## ADDENDUM #5

**Western Slope Food Bank of the Rockies**  
698 Long Acre Drive

**Bid Package #4 – Above Ground**

September 10, 2021

DATE: 8/25/2021 SHEET NO:

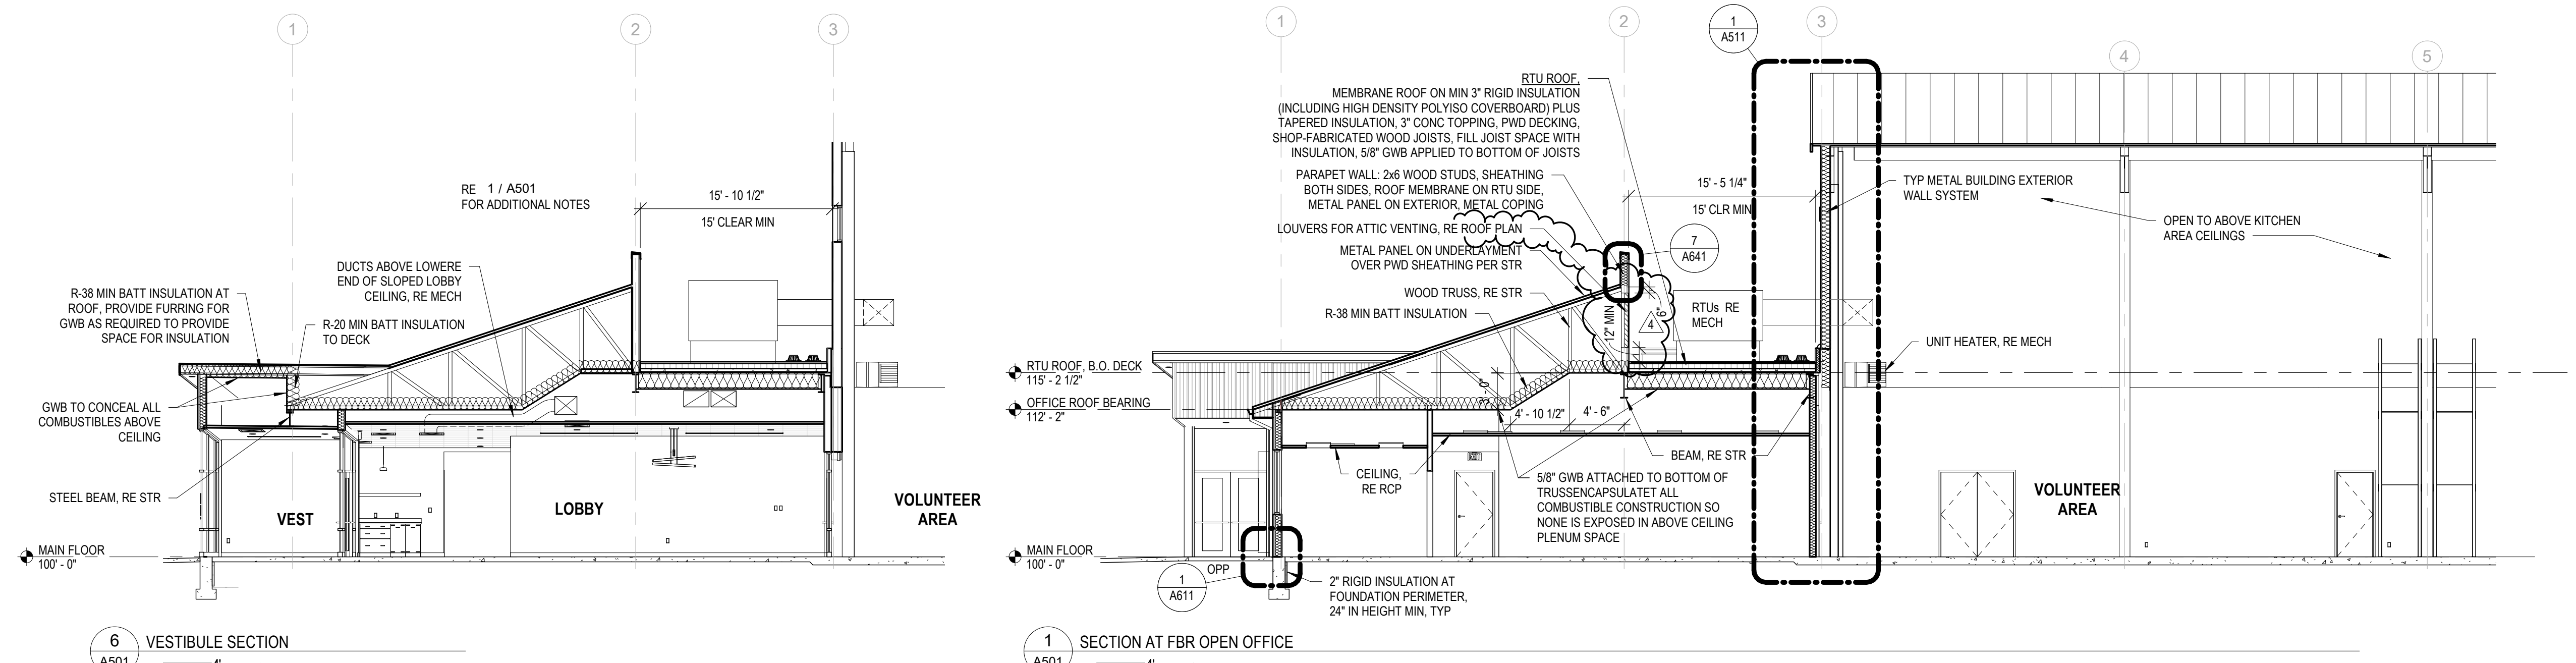
- ADD5-17 Sheet A403 Interior Elevations: Delete sheet and replace with attached revised sheet A403.
- ADD5-18 Sheet A501 Building Sections: Change detail 1 per attached revised sheet A501.

PROJECT NO. **M101**

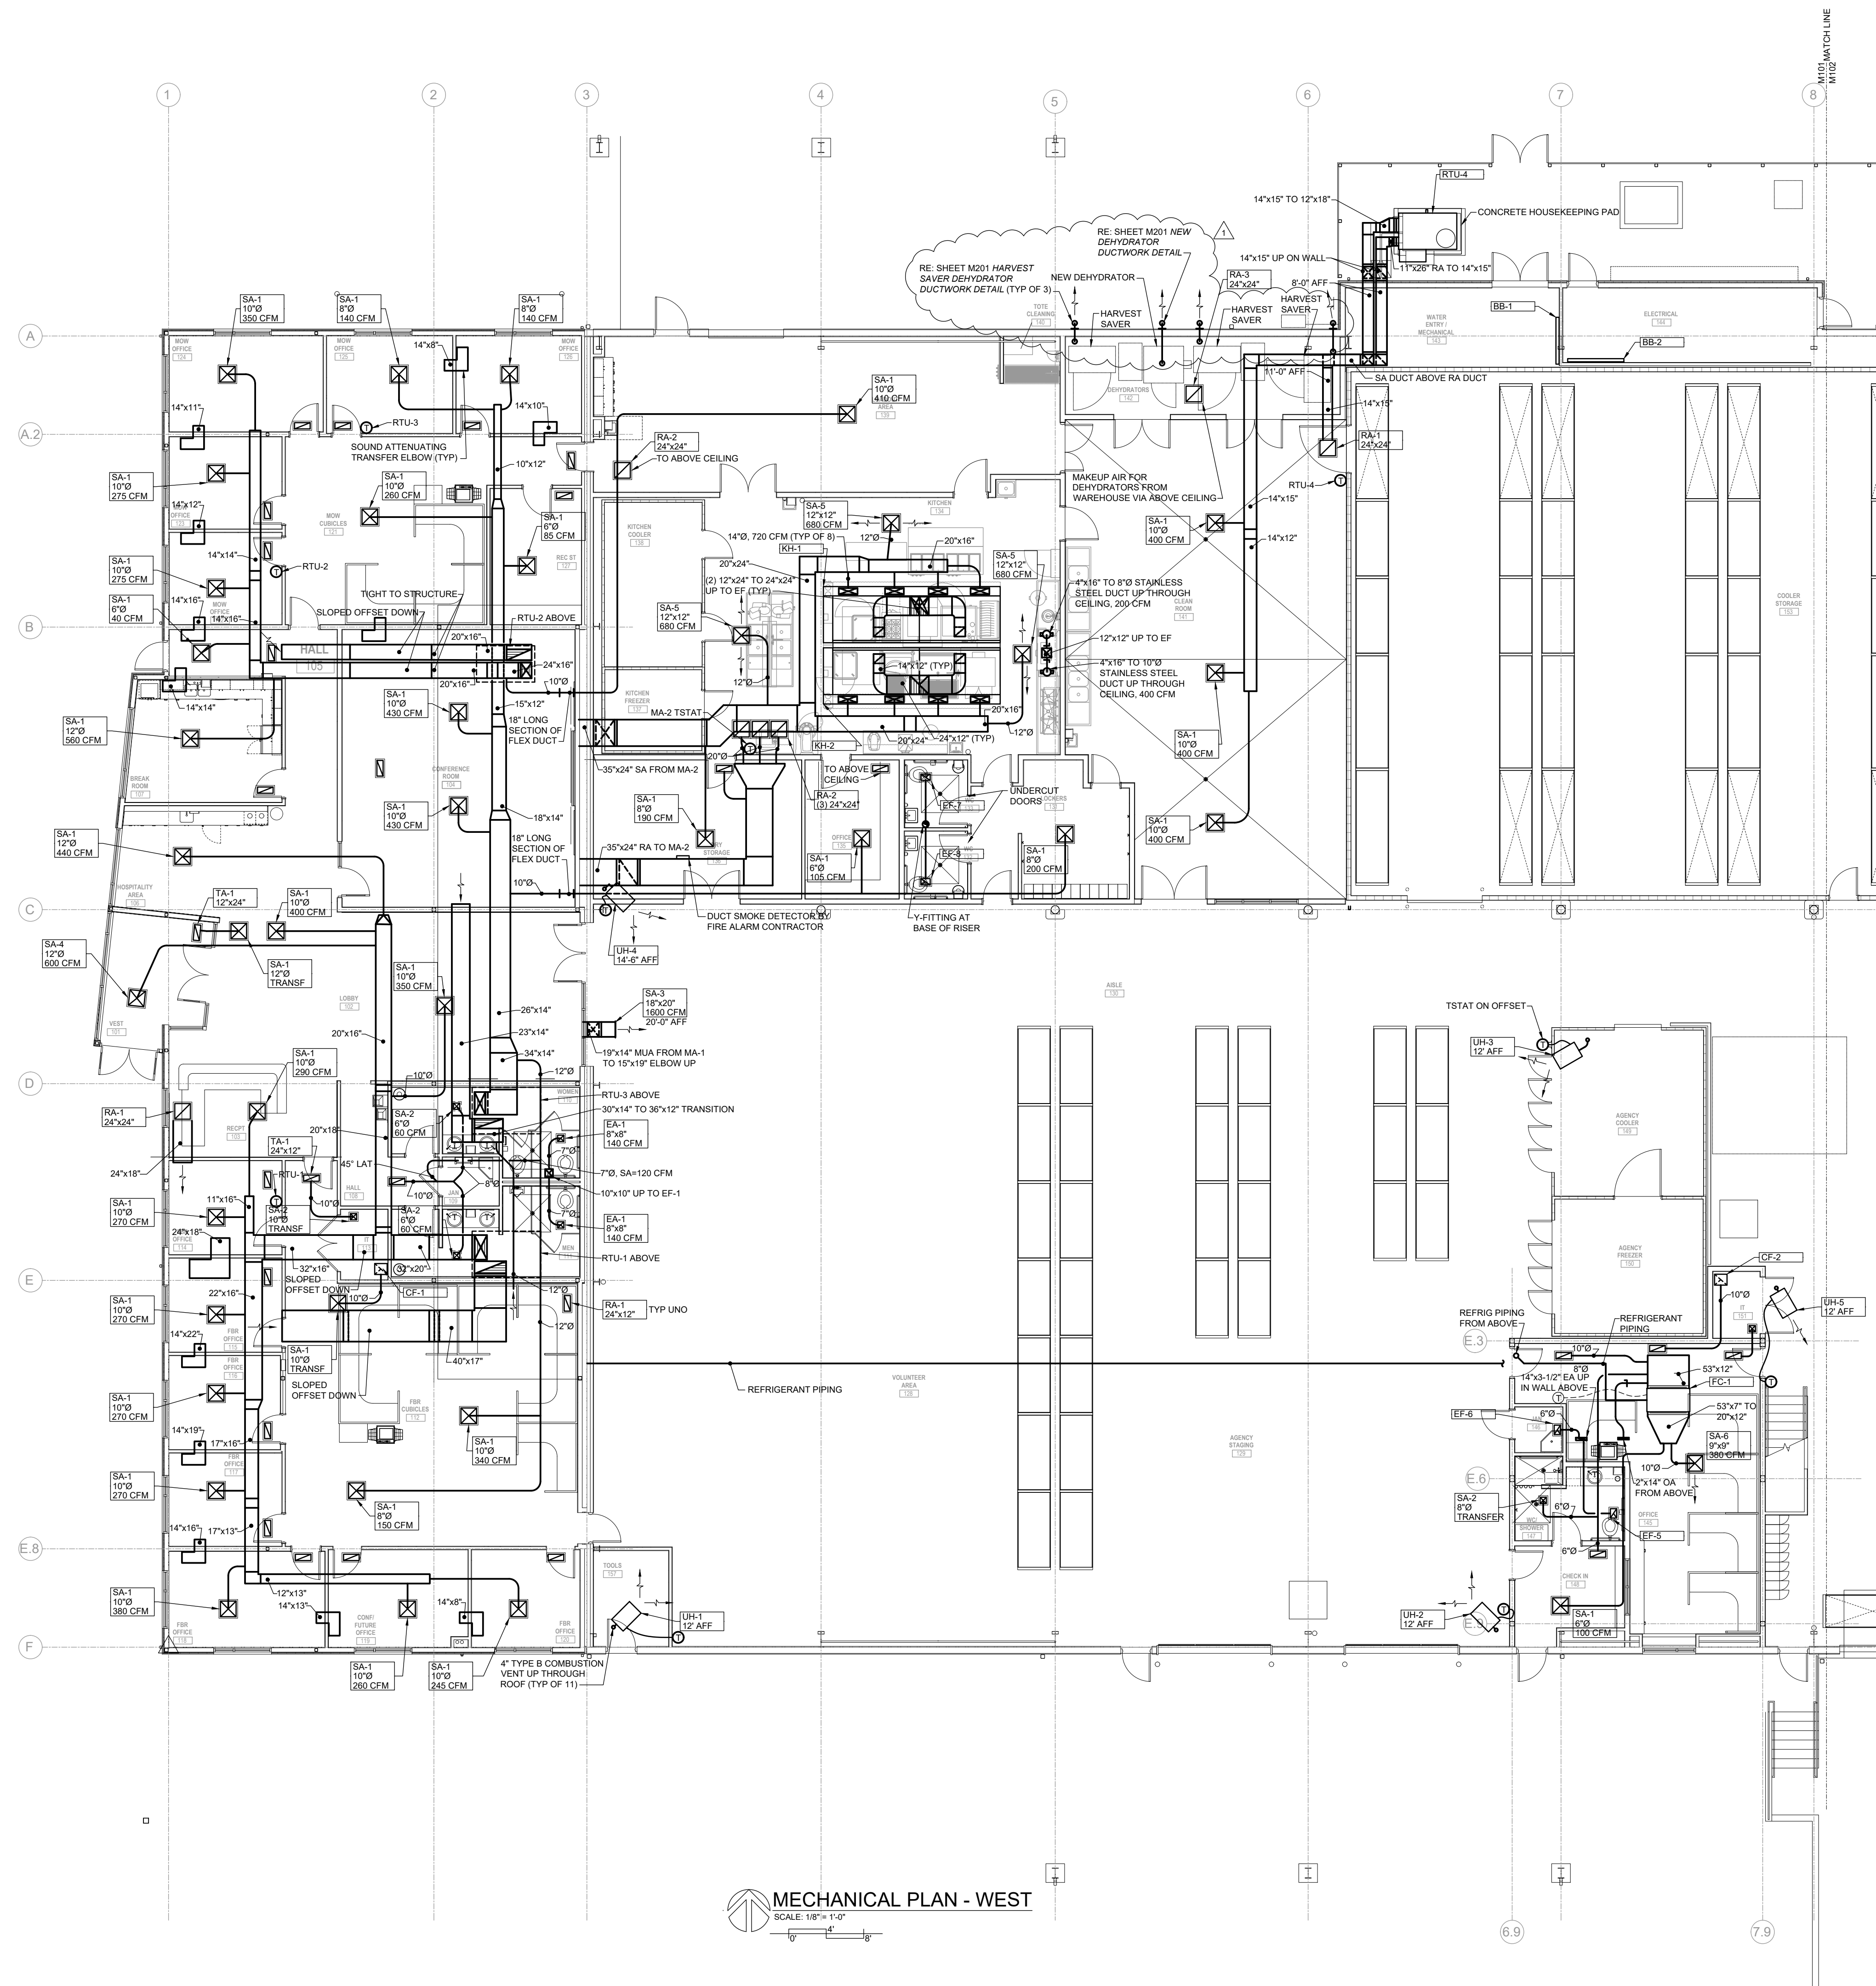
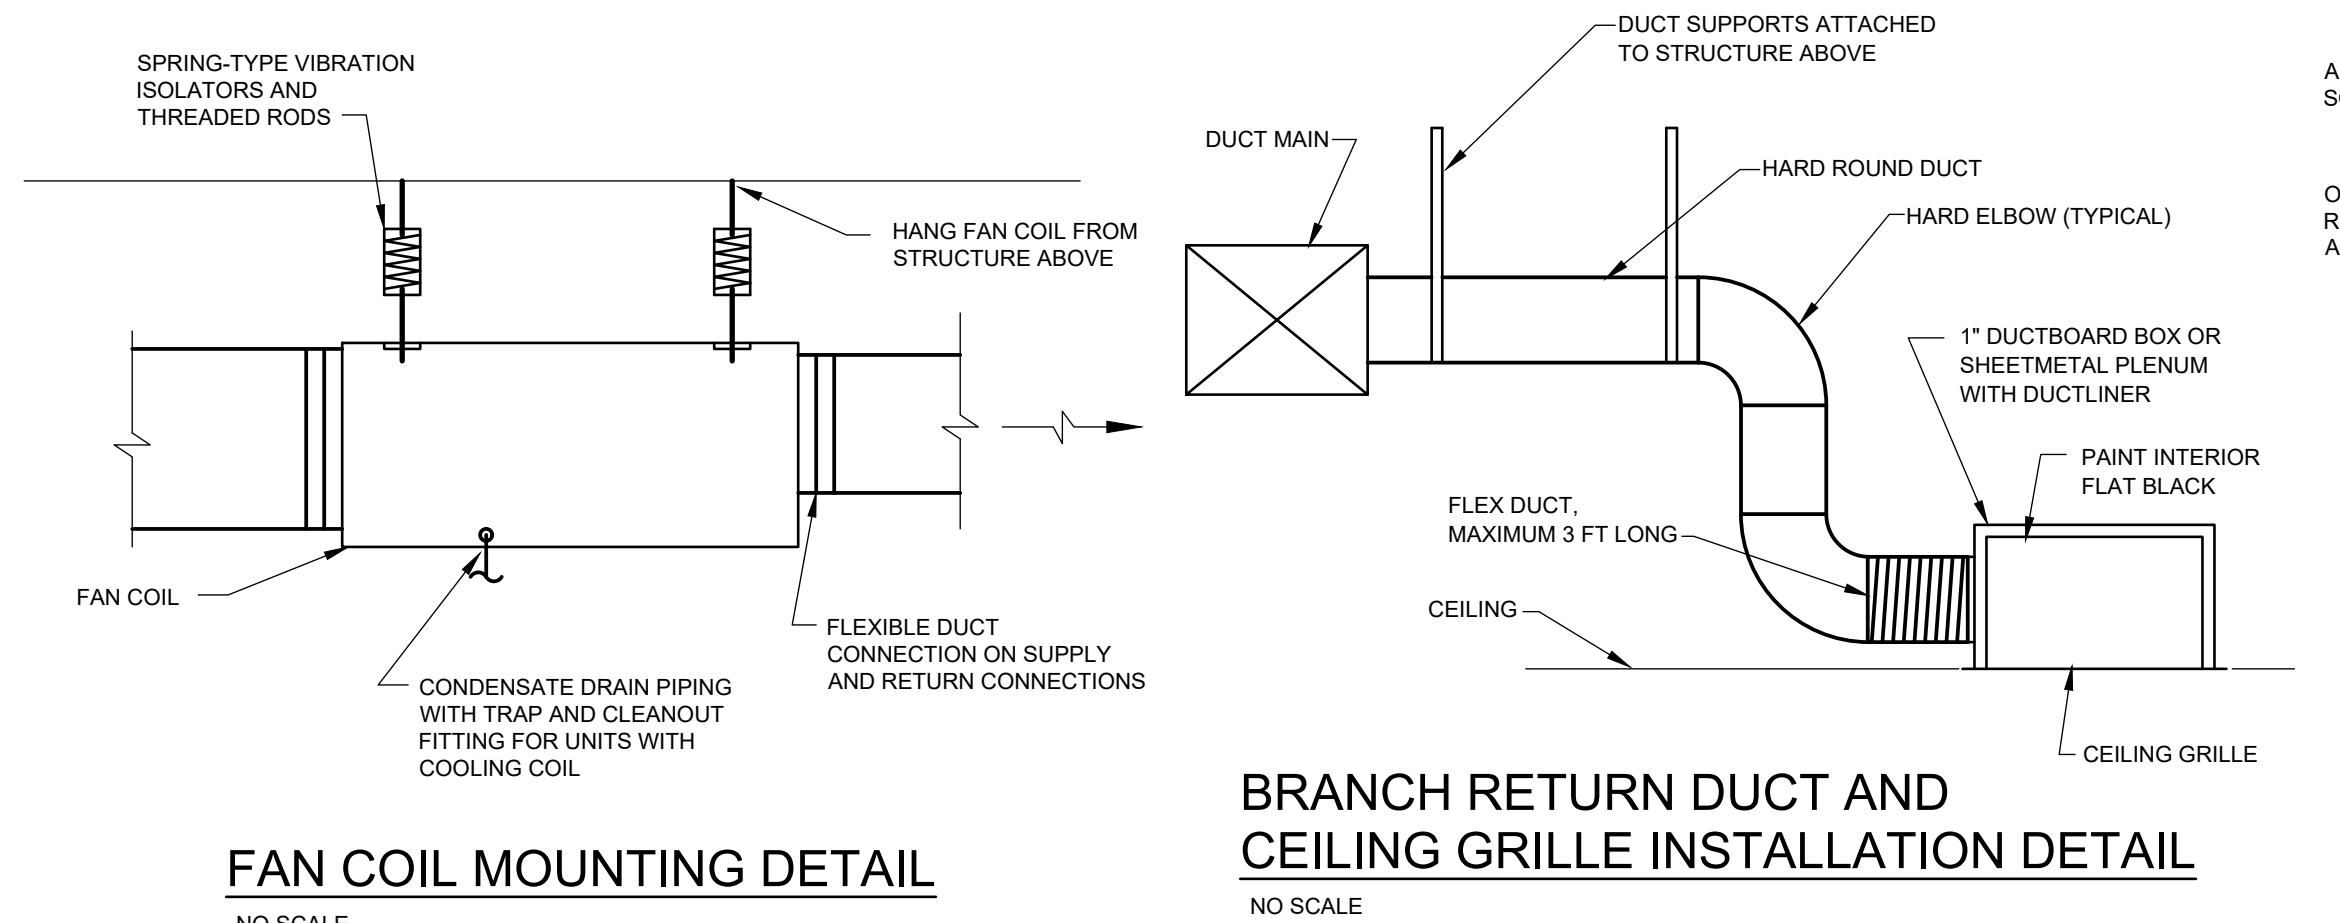
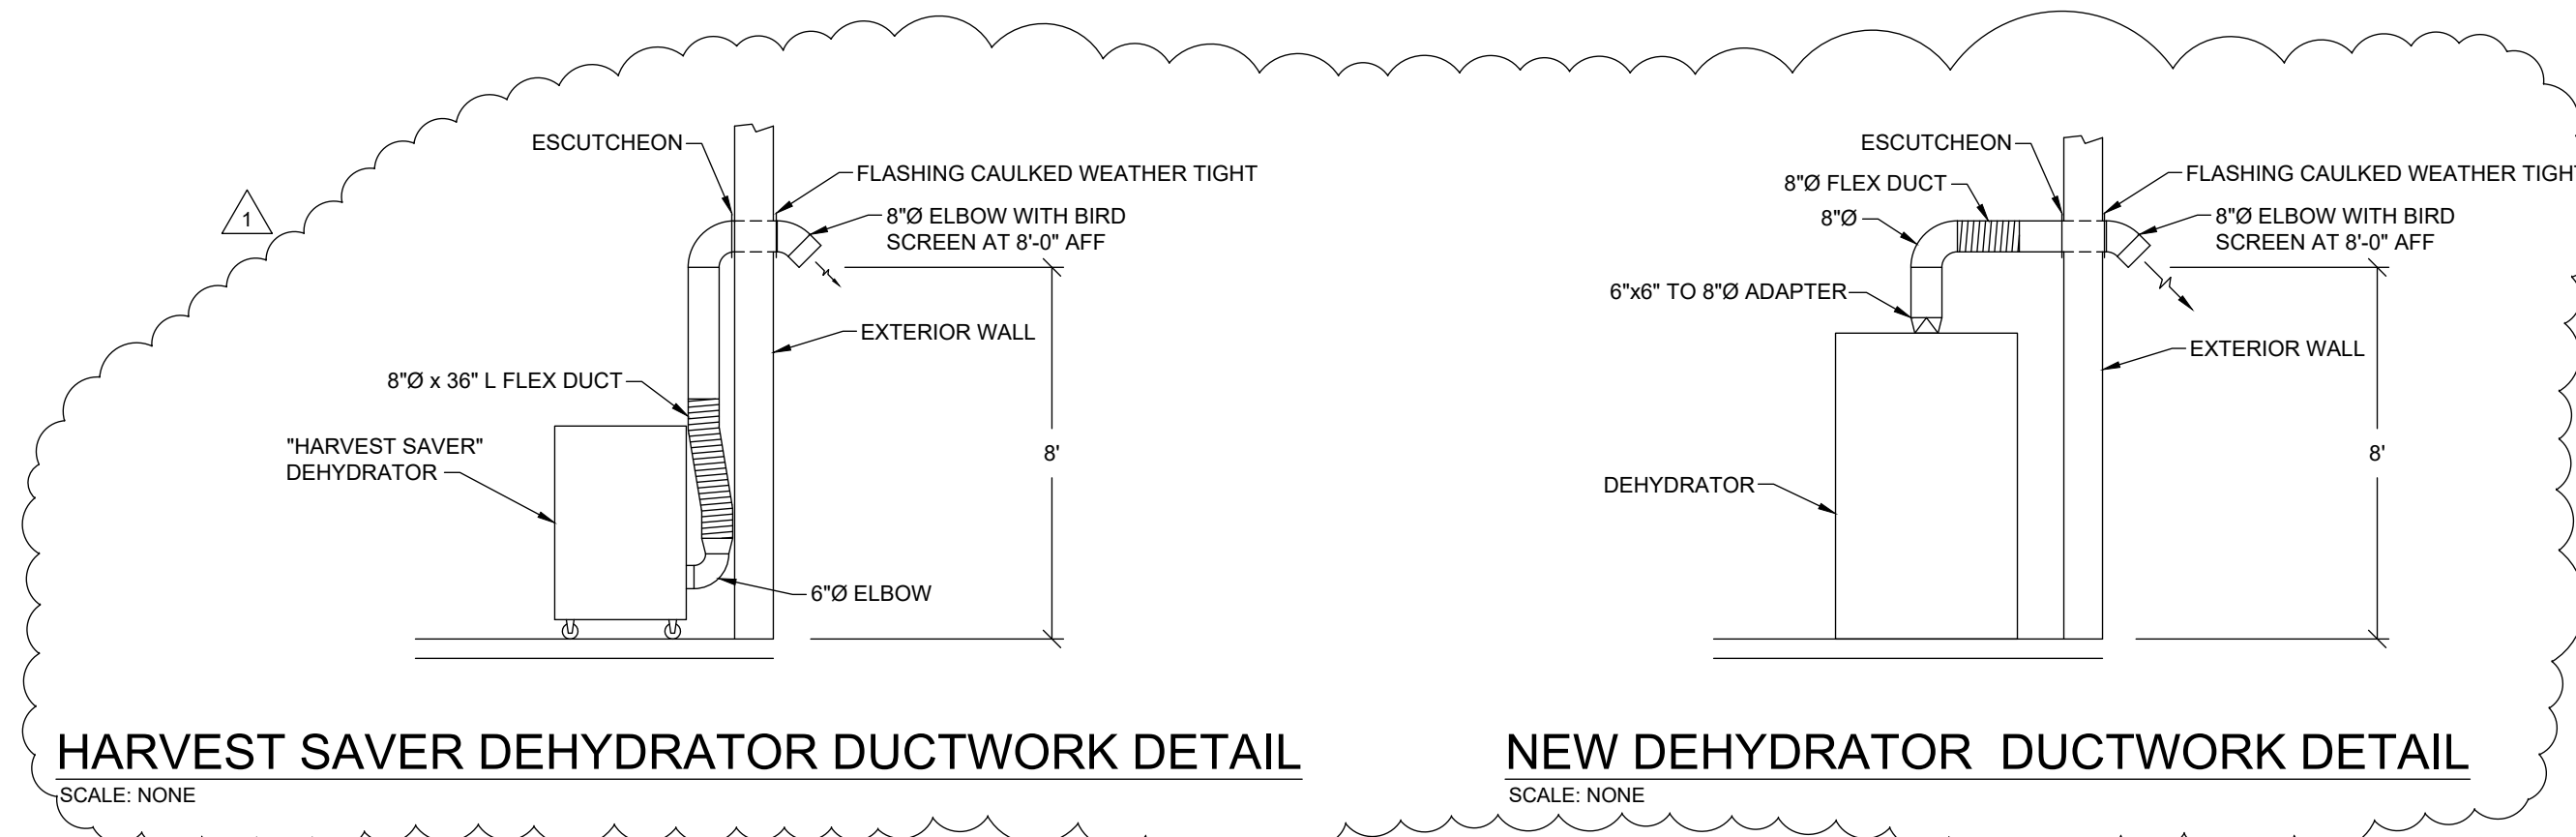
- ADD5-19 Sheet M101 Main Level Mechanical Plan - West & Second Floor Office: Delete sheet and replace with attached reissued sheet M101.
- ADD5-20 Sheet M201 Mechanical Details & Legend: Add Dehydrator Ductwork Details per attached reissued sheet M201.
